ISSUE: Permit to Demolish/Capsulate (partial) and Certificate of Appropriateness for alterations

APPLICANT: 910 King Street, LLC

LOCATION: Old and Historic Alexandria District
910 King Street

STAFF RECOMMENDATION

Figure 3: Decorative metalwork on top of knee wall above projecting bay

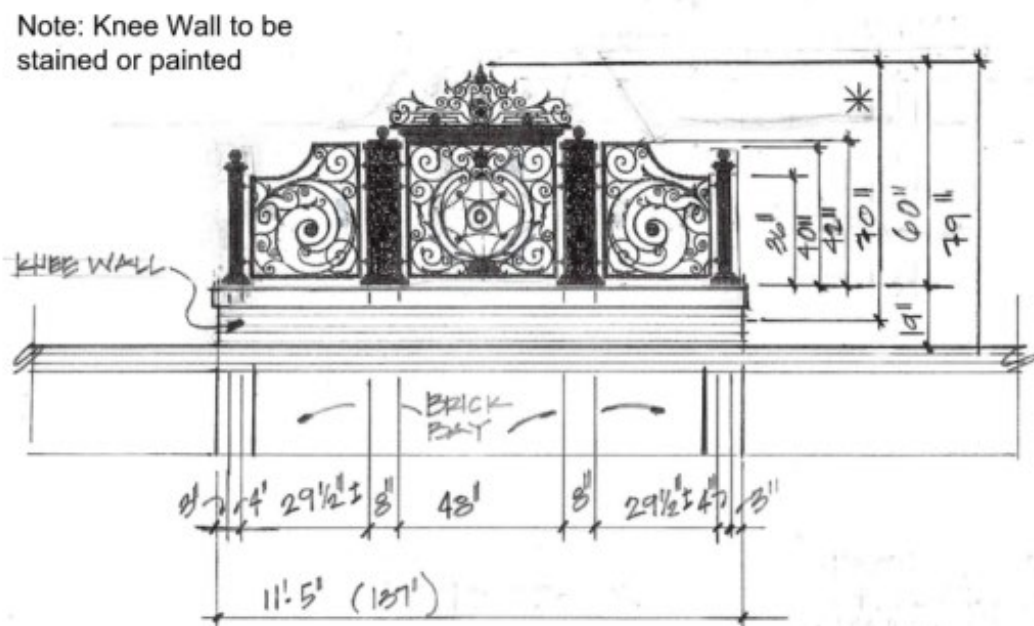
The applicant is proposing to install decorative metalwork attached to the top of the knee wall located above the projecting bay extending above the roof (Figure 3). In previous reviews of this proposal, Board members have expressed concern with the size and design of this metalwork.

Staff appreciates that elements of the design have been taken from the decorative brickwork on the front of the building, however the size and complexity of this element overpower the historic building. As noted in the submission material, the building across King Street from the subject property has many of the same historic details and in many ways can be considered a sibling to this building. At the top of the projecting bay on this building is a decorative slate roof with a simple metal embellishment (Figure 4). This is in place of the masonry knee wall at the top of the bay on 910 King Street. Staff finds that the metalwork proposed for the top of the knee wall is incompatible with the design of the historic building and recommends that the applicant work with staff to design a metal embellishment of approximately the same scale and complexity as the one on 913 King Street.

4. The proposed metalwork at the top of the knee wall is incompatible with the design of the building, if an embellishment is installed in this location the applicant will work with staff to design an element of approximately the same scale and complexity as the one on 913 King Street.

East, West and
South Elevations

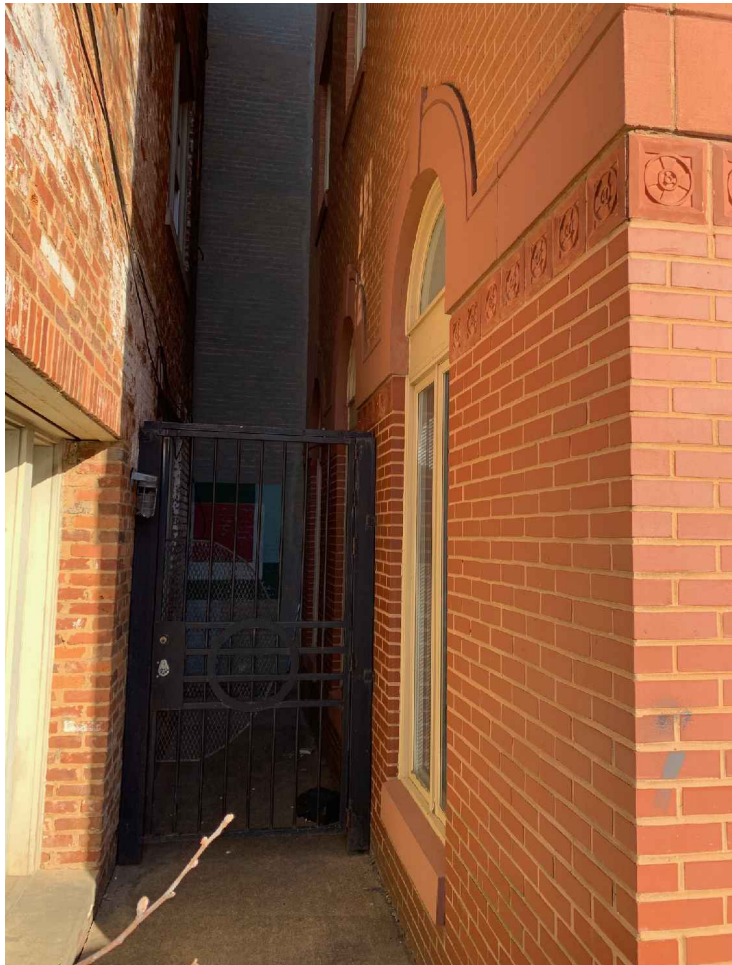
Per the submission materials, the applicant is proposing to repair and repaint the exterior masonry on east, west, and south sides. The Board has long considered the painting of unpainted masonry to be discouraged as it constitutes a significant change to the architectural character of the building.

As noted above, until the mid-twentieth century an adjoining building was attached to the west side of the current building. At the south side of the building was originally located an ell which predated the construction of the portion of the building remaining today. As these two elevations were not intended to be exterior walls, the masonry in these areas is not of a finished quality. At the east side of the building is a narrow alley allowing for limited access to this portion of the building. Note that the Board recently approved the infill of windows on this elevation. Given that the south and west walls were not intended to be exterior walls and that the visibility of the east wall is limited, staff recommends approval of the painting of these three elevations.

Front Steps

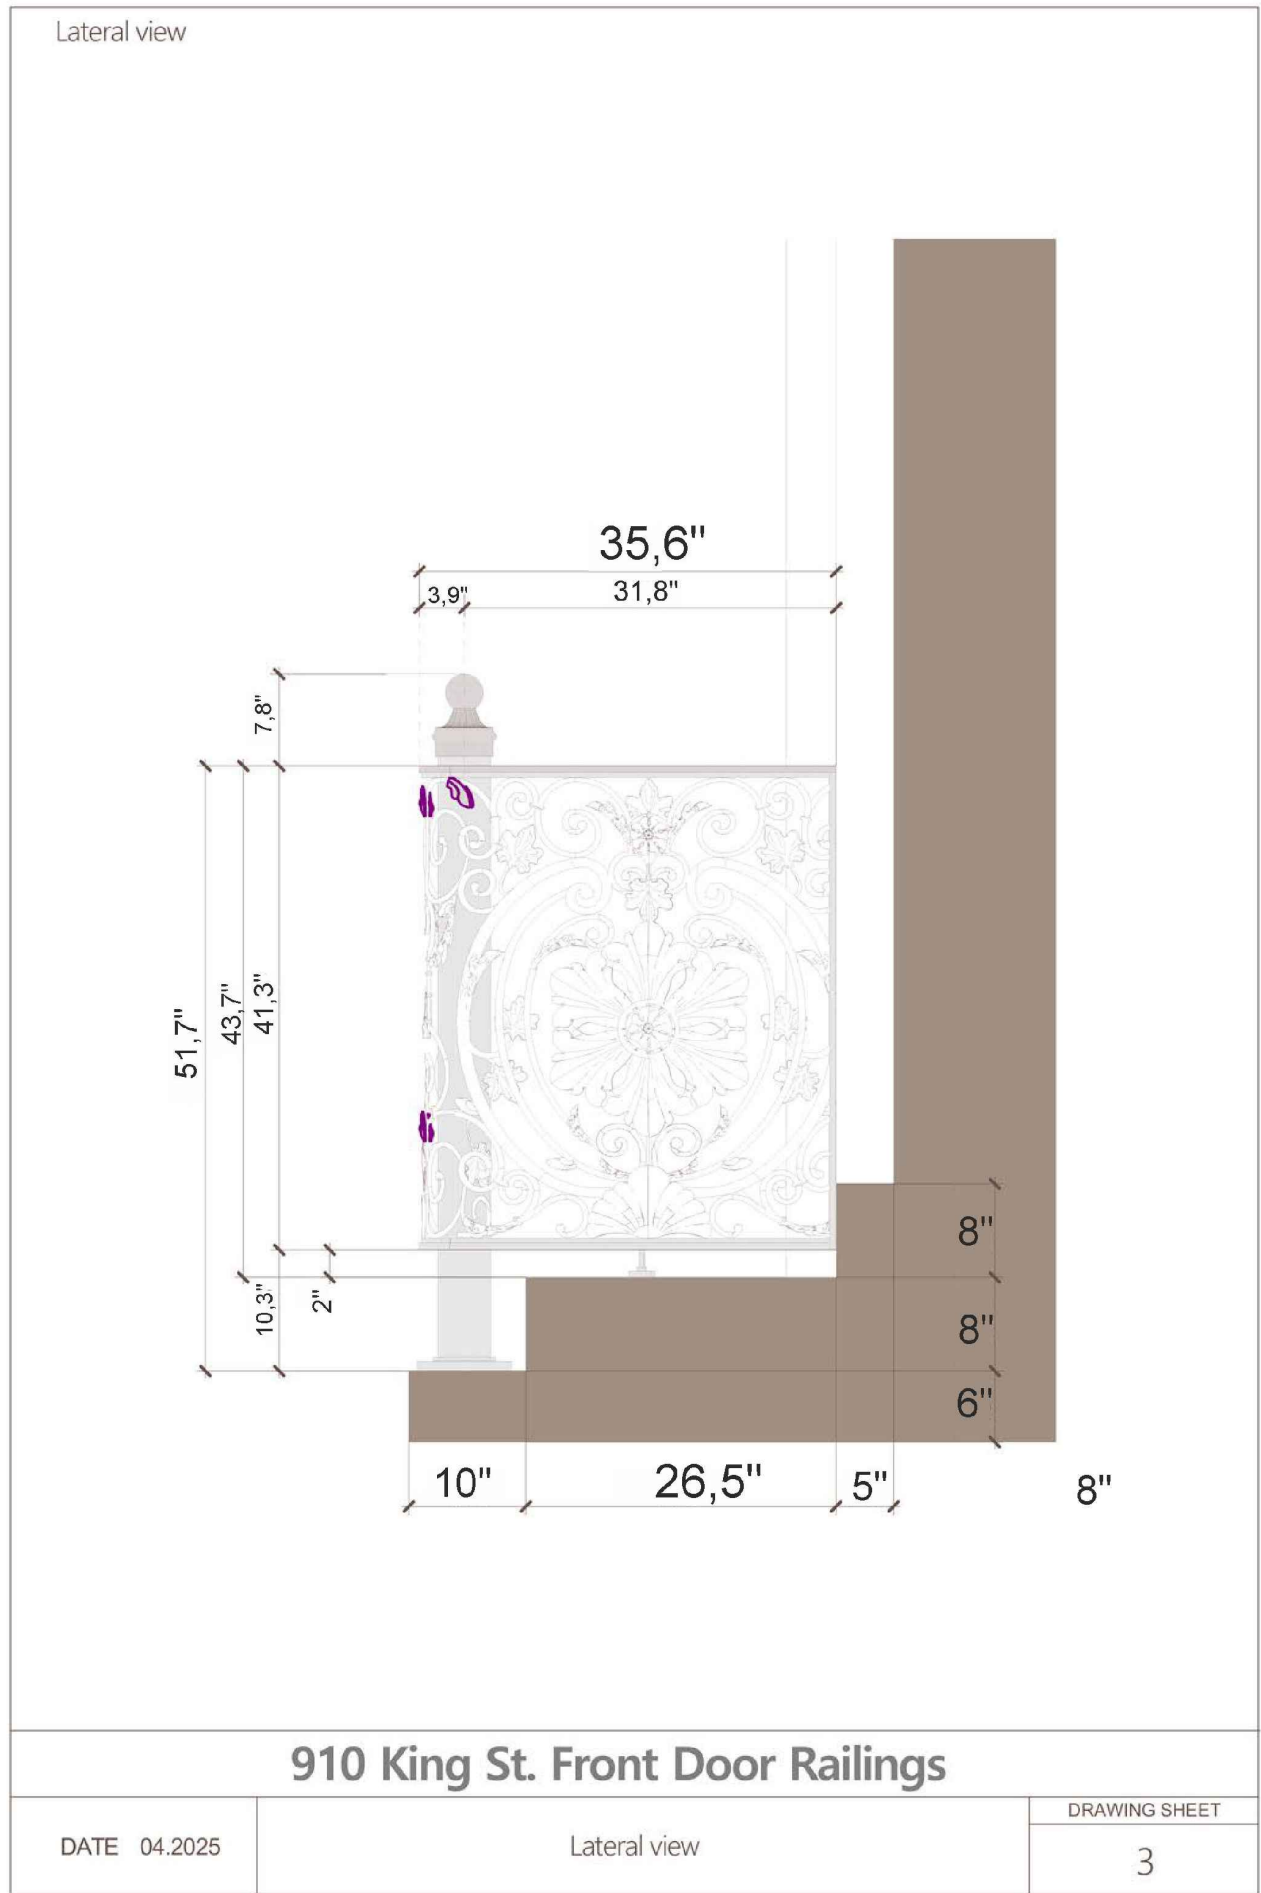
The applicant is proposing to retain and repair the stone steps at the main building entry and stain them to match the existing color. As with the detail elements noted above, the entry stones should only be stained as necessary due to damage to the stone.

2. Staining of the stones at the building entry should be done only where necessary due to damage to the existing stones.
3. The applicant work with staff to simplify the design of the metal scrollwork at the entry door and that the existing transom be retained and any metal work applied to the transom be easily removable.
